# The Second CERCLA Five-Year Review Report for the Hanford Site

Date Published  
November 2006

5.0	References .....	5.1
	Appendix A – Institutional Controls.....	A.1
	Appendix B – Response to Comments .....	B.1

Figure 2. Source Operable Units on the Hanford Site

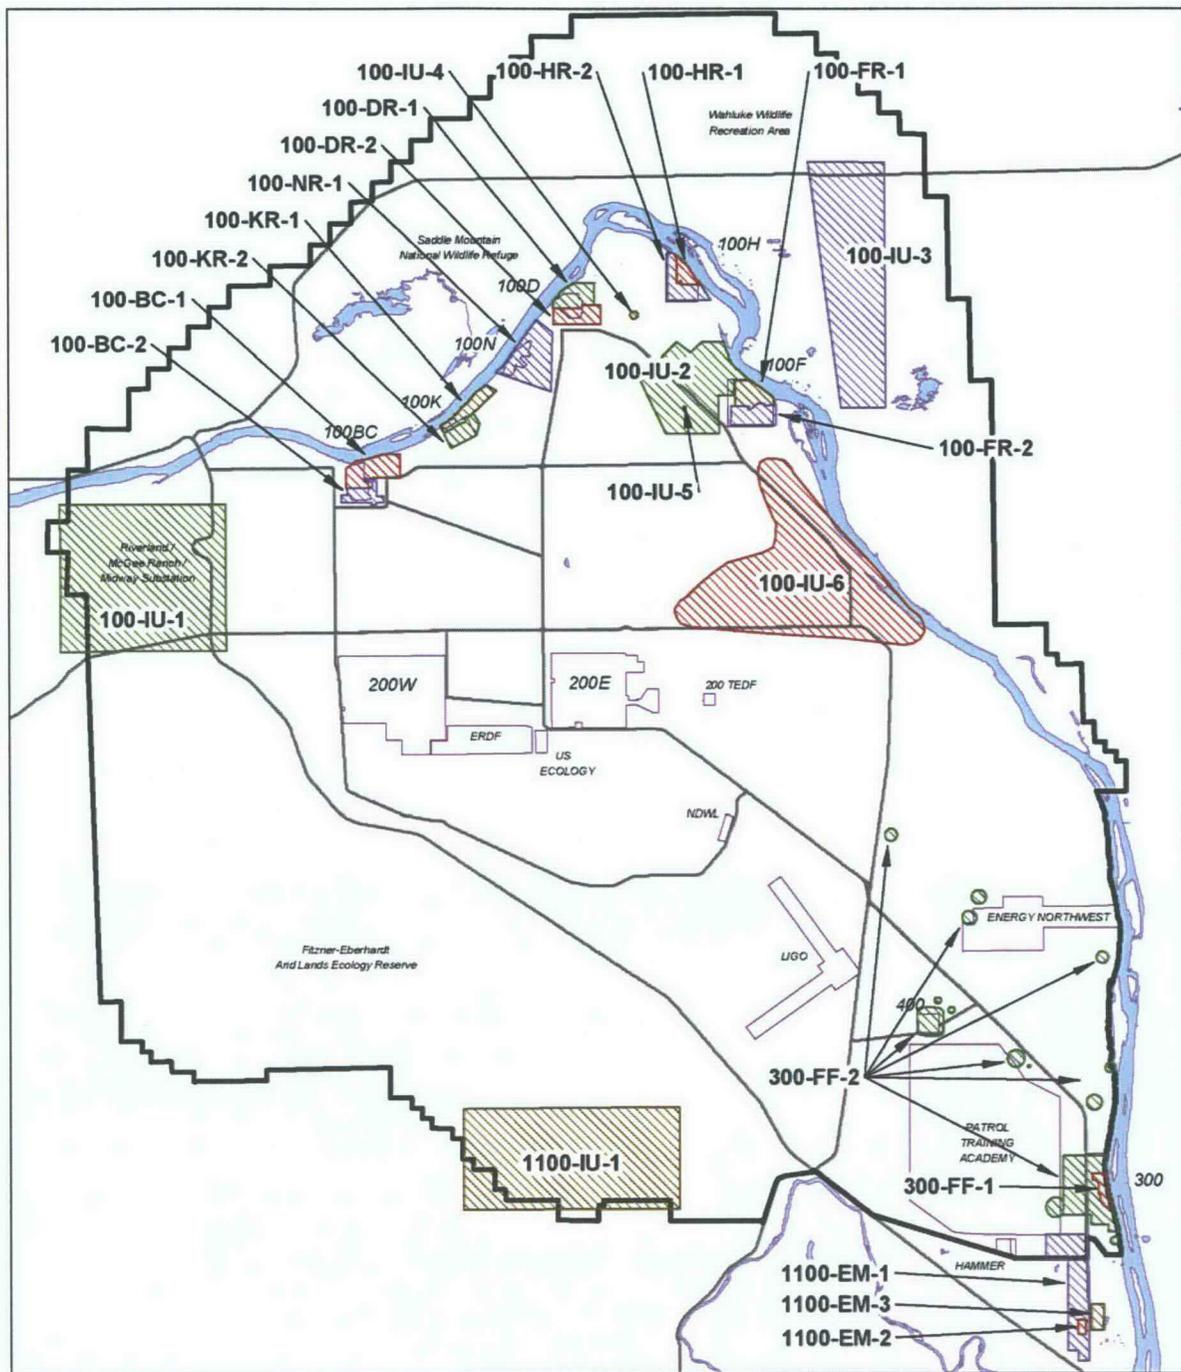
**Comment 34:** Figure 2 shows only one small area in the 200 Area, although there are many scattered sites and 24 soil OU groupings.

**Response to Comment 34:** DOE agrees, the figure does not adequately show the 200 Area operable units. The 200 Area source operable units are shown on Figures 2.1 and 2.2.

**Figure 3.** Groundwater Operable Units and Groundwater Interest Areas on the Hanford Site

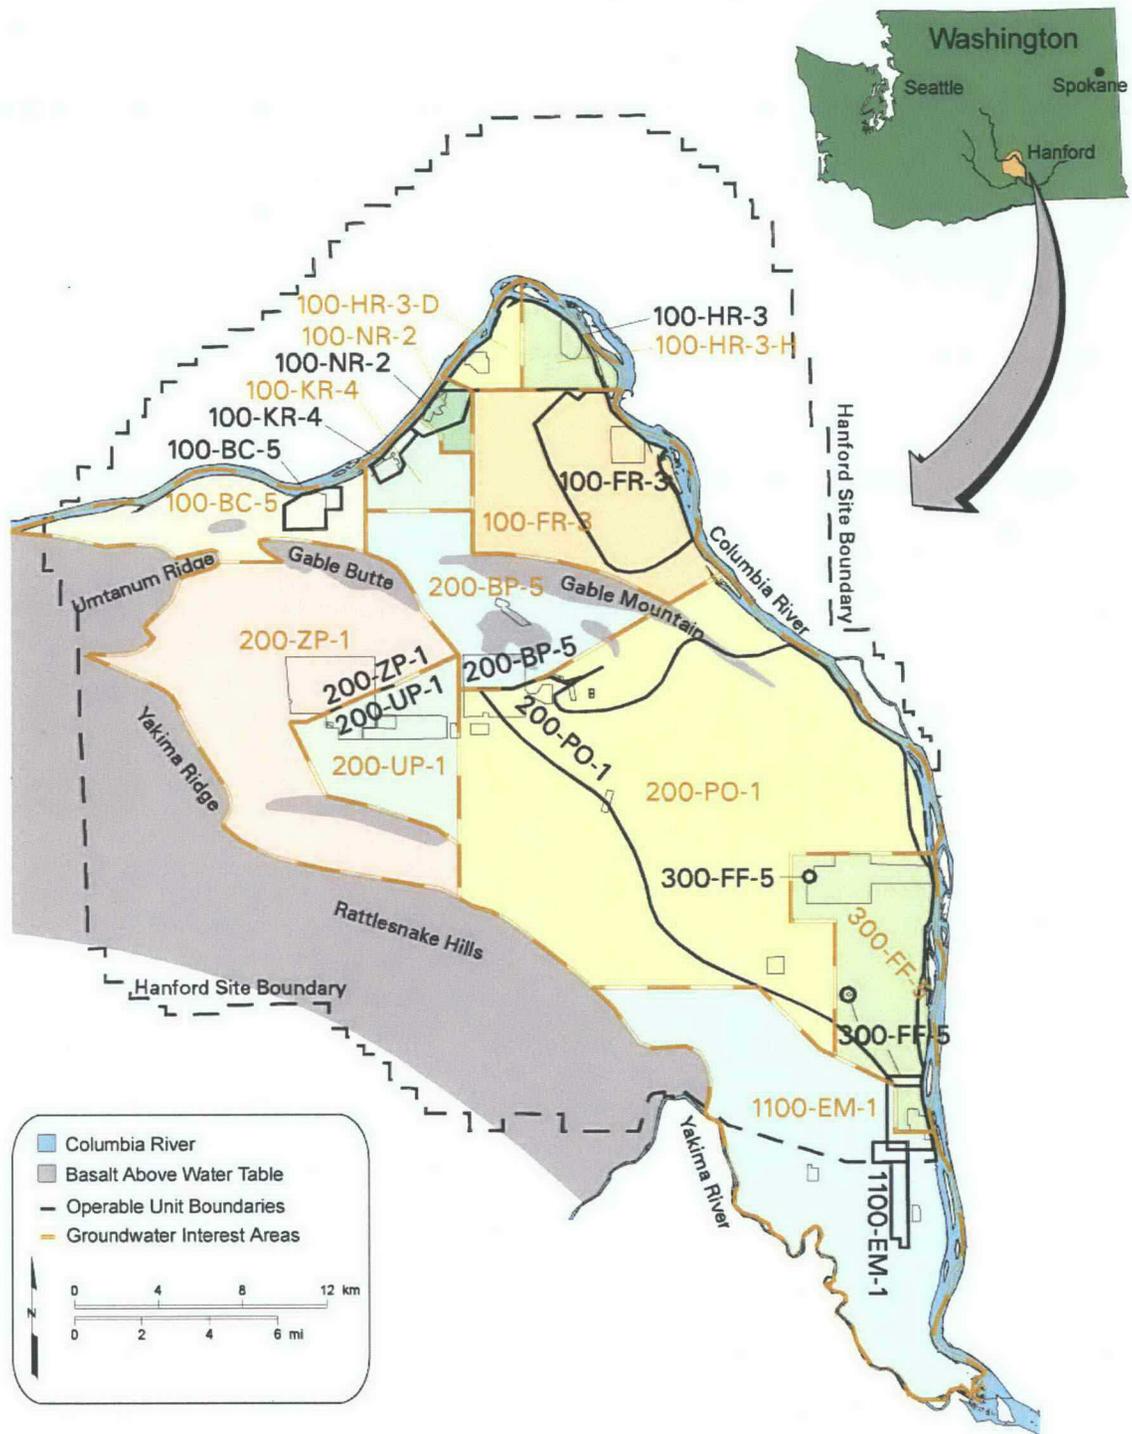
**Comment 36:** Comparing Figures 2 and 3 shows widely divergent Area boundaries – small sources at the surface and huge areas for groundwater. In a 3-D perspective, then, each operable unit would actually be a misshapen cone with the source at the tip, the groundwater at the bottom, and an unknown mass of contaminated soil in between.

Figure 1.4. 100-N Area Operable Units

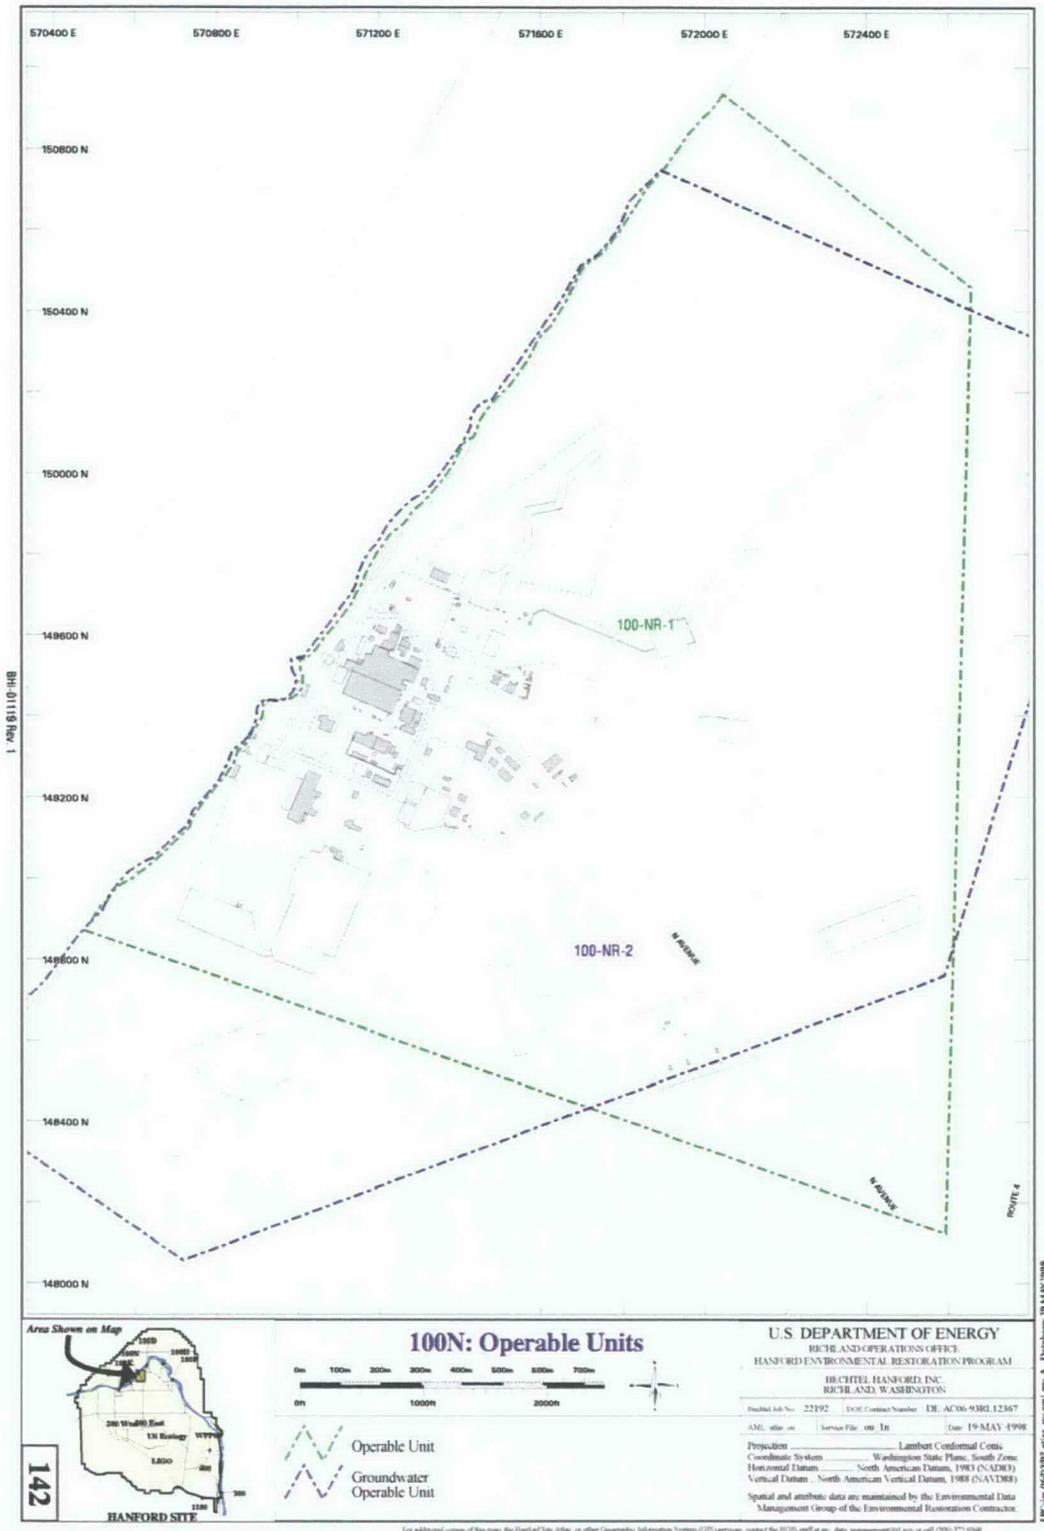
**Comment 32:** The boundaries in Figures 1-4 do not match existing maps for the 100 Area. For example, the 100 Area is variously drawn as the entire River Corridor, a string of pearls (the Reactor Areas), large amorphous areas of groundwater plumes, or larger areas that encompass all of Hanford except the 200 and 300 Areas.

**Response to Comment 32:** Figure 1-4 shows the 100-N Area operable units. It is unclear which maps it is being compared against. See the previous response to Comment 31.
